Re: **Comments on the Revised Environmental Analysis for the Proposed Short-Lived Climate Pollutant Reduction Strategy Dated November 28, 2016**

Re: **Comments on the Draft Environmental Analysis for the Proposed Short-Lived Climate Pollutant Reduction Strategy Dated April 11, 2016**

SUBJECT: COMMENTS ON PROPOSED SHORT-LIVED CLIMATE POLLUTANT REDUCTION STRATEGY (SLCP STRATEGY)

TECHNICAL ASSESSMENT OF THE SHORT-LIVED CLIMATE POLLUTANT STRATEGY

Figure 1: Corn N uptake throughout the growing season in relation to major growth stages (created with data from Karlen, D.L., R.L. Flannery, and E.J. Sadler. 1988. *Aerial Accumulation and Partitioning of Nutrients by Corn*. *Agron. J.* 80:232–242).

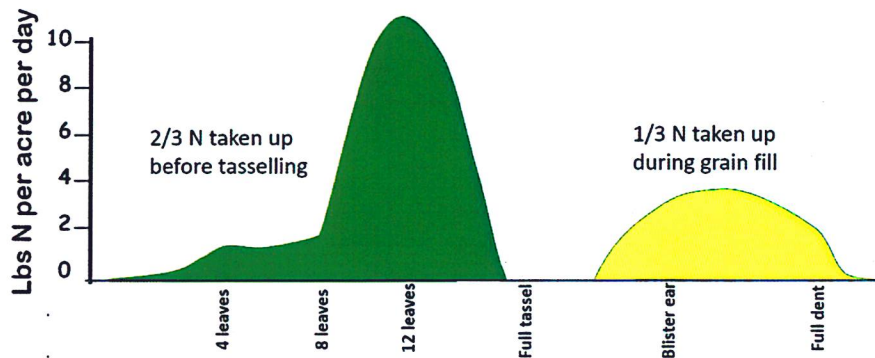
Applying N to the plant when it needs it is one of the “4Rs of nutrient stewardship” in agriculture (i.e., right source, right rate, right time, right place) which is supported globally and born of the International Plant Nutrition Institute (IPNI). The 4Rs provide the conceptual basis for best management practices (BMPs) to achieve cropping system goals: minimizing field nutrient loss and maximizing crop uptake to attain optimum yield and quality. This can be done with manure in liquid form, as generated on flush dairies. Specifically, dairymen inject liquid manure into the irrigation water to apply small, targeted amounts of N to match crop demand throughout the season. This practice is sometimes referred to as “spoon feeding,” and it is similar to the widespread practice of injecting liquid synthetic fertilizers (e.g., anhydrous ammonia) into the irrigation water stream on farms that do not have access to organic fertilizer sources. This N delivery strategy cannot be done with solid manure (dry or slurry) or composts because these materials are broadcasted with spreader trucks and the window of opportunity for broadcasting is between crop rotations (i.e., typically pre-plant). Solid manure applications are valuable to the overall soil and plant health. However, they need to be carried out in moderation (i.e., at the right rate) due to the small plant N demand following the weeks after application. Over-application has the potential to induce leaching losses associated with irrigation events when the crop root system is in its early stages, while not supplying sufficient N when crop N demand sharply increases at the 8-leaves stage.

In conclusion, the proposed conversion removes dairy operators’ ability to locally recycle manure nutrients by fertilizing their forage crops at the right rate throughout the crop growing season. It assumes that this will improve groundwater quality protection with neither consideration of alternative modes of N delivery and their effect on groundwater quality nor consideration of practical consequences to on-farm nutrient management
